**Addendum 1**  
**Bid 20-99426**  
**OUTFALL REPAIRS ON CONGDON BLVD**

## 7428 and 7825 Congdon Blvd

### List of Questions/Answers from Pre-Bid Meeting

## 7428 CONGDON BLVD BIN WALL STABILIZATION DULUTH, MN

1 EXISTING BIN WALL ELEVATION

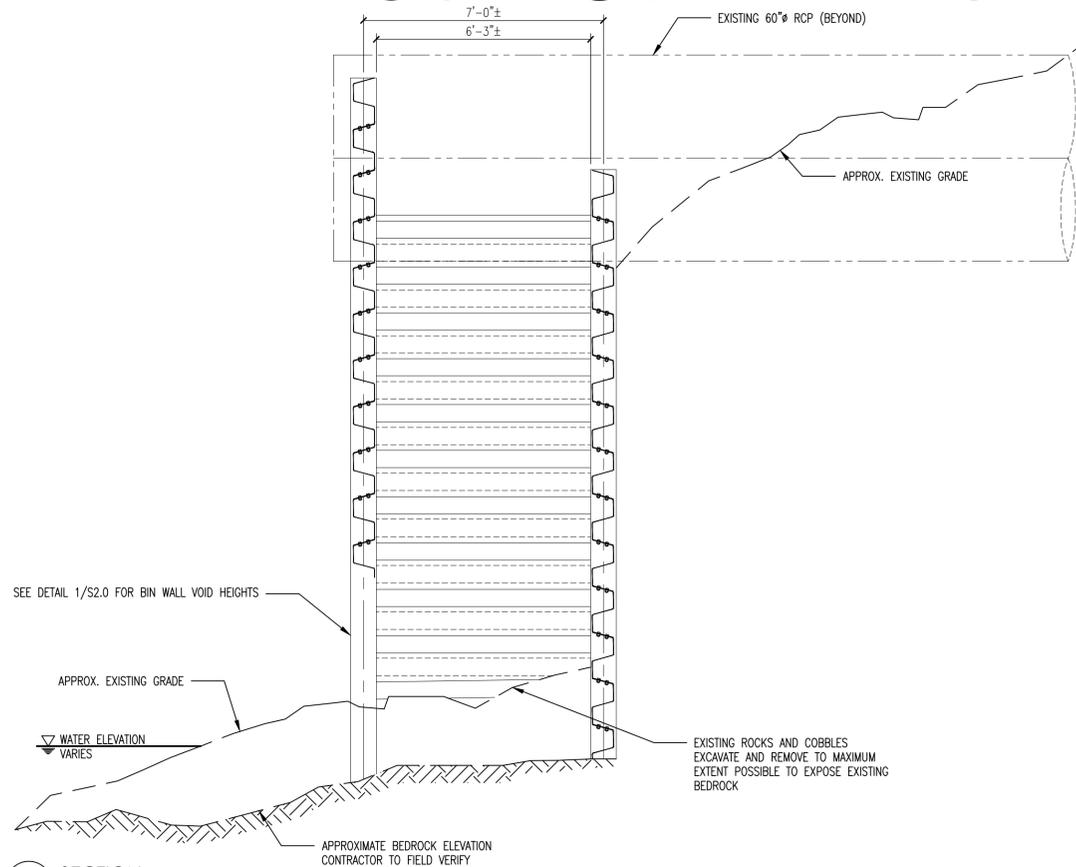
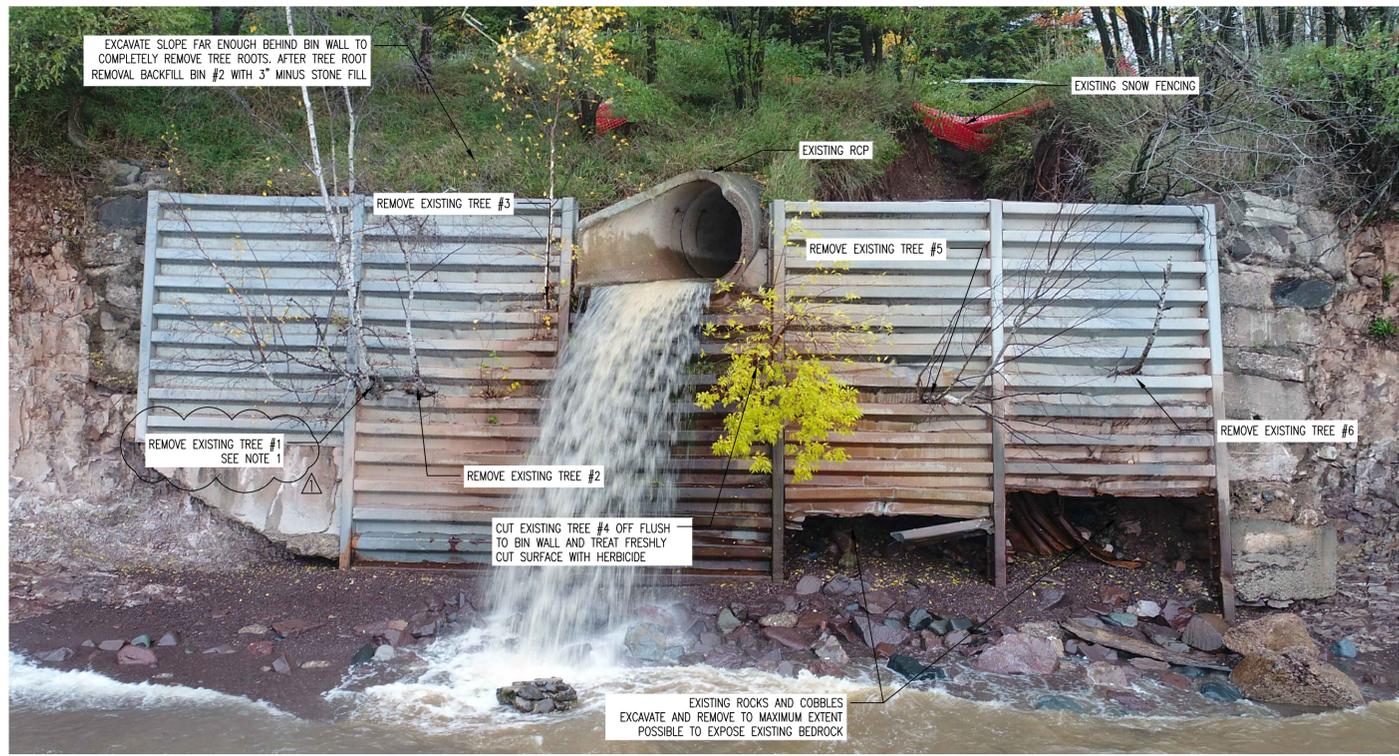
- b. The Contractor shall verify the extent of the void in Bin #3 below the existing RCP prior to installation of galvanized steel plates or placement of concrete.

- c. Concrete fill shall be placed in the void in Bin #3 from the top of the bin wall to the maximum extent possible without removal of existing RCP. The Contractor shall place fill in each bin in equal lifts to not overload the members separating the bins. The Contractor shall begin filling the largest voids first and shall only start filling the adjacent bins when the fill material and the existing soil elevation in adjacent bins are at equal elevations. For example, concrete shall not be placed in Bin #3 until concrete has been placed in Bin #4 and #5 to an elevation equal to the bottom of the void in Bin #3 and 3" minus stone fill has been placed in Bin #2 to an elevation equal to the bottom of the void in Bin #3. Bins #2, #3, #4, and #5 shall then be filled in equal lifts to the top of the existing bin wall.

- SCALE: 3/8"=1'-0"
- SEE DETAIL 3/S2.0 FOR PICTURE OF BIN WALL CONDITION AT TIME OF INSPECTION (OCTOBER 2019).
  - EXISTING GRADE ELEVATION MAY VARY DUE TO WAVE ACTION AND SHORELINE EROSION. CONTRACTOR TO FIELD VERIFY GRADE AND BEDROCK ELEVATIONS PRIOR TO CONSTRUCTION.
  - HERBICIDE TREATMENT TO BE APPLIED TO FRESHLY CUT SURFACE SHALL BE SUBMITTED FOR APPROVAL. TREATMENT SHALL BE APPLIED IN ACCORDANCE WITH MANUFACTURER'S RECOMMENDATIONS.
  - CONTRACTOR RESPONSIBLE FOR VERIFYING VOID HEIGHT IN BIN #3

**3 REINFORCED CONCRETE PIPE REPAIRS**  
SCALE: NTS

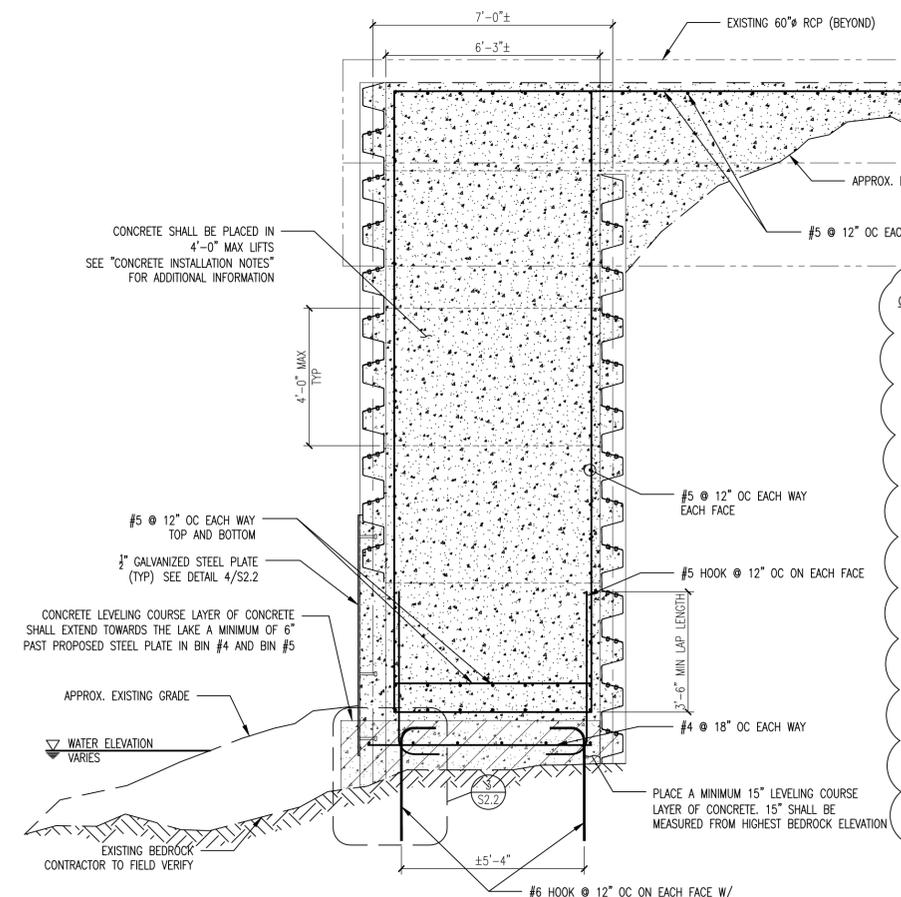
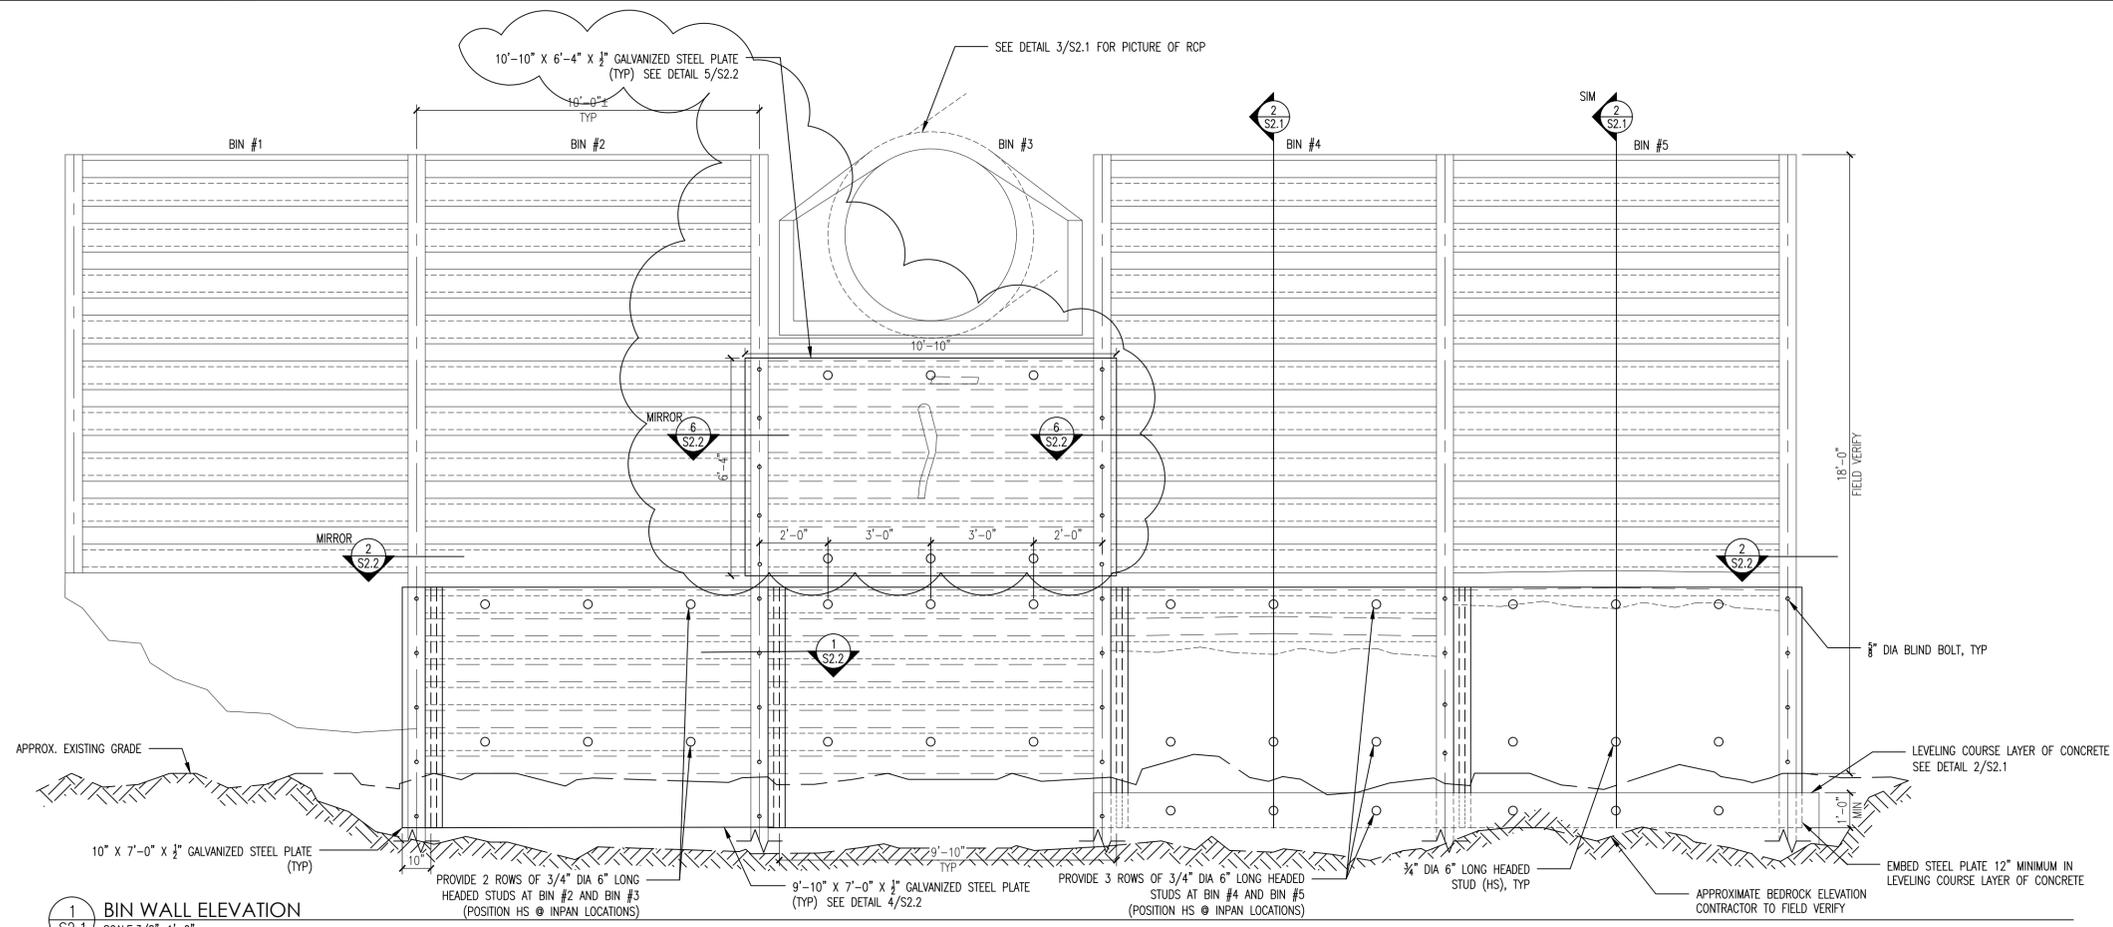
4. 7428 Congdon Blvd existing 60"Ø RCP
  - a. Water was documented leaking from bottom of RCP at second joint back from outfall opening into Lake Superior. Contractor shall inspect joints in existing RCP and repair leaks and other deficiencies as required.

- b. Contractor shall divert drainage as require and provide plug in 60"Ø RCP to facilitate repairs if determined necessary by Contractor.
5. 7428 Congdon Blvd Bin #3

- CONTRACTOR SHALL DIVERT DRAINAGE AS REQUIRED AND PROVIDE PLUG IN RCP TO FACILITATE JOINT REPAIRS.
- PHOTO REPRESENTATIVE OF CONDITIONS ON 06/19/2020.
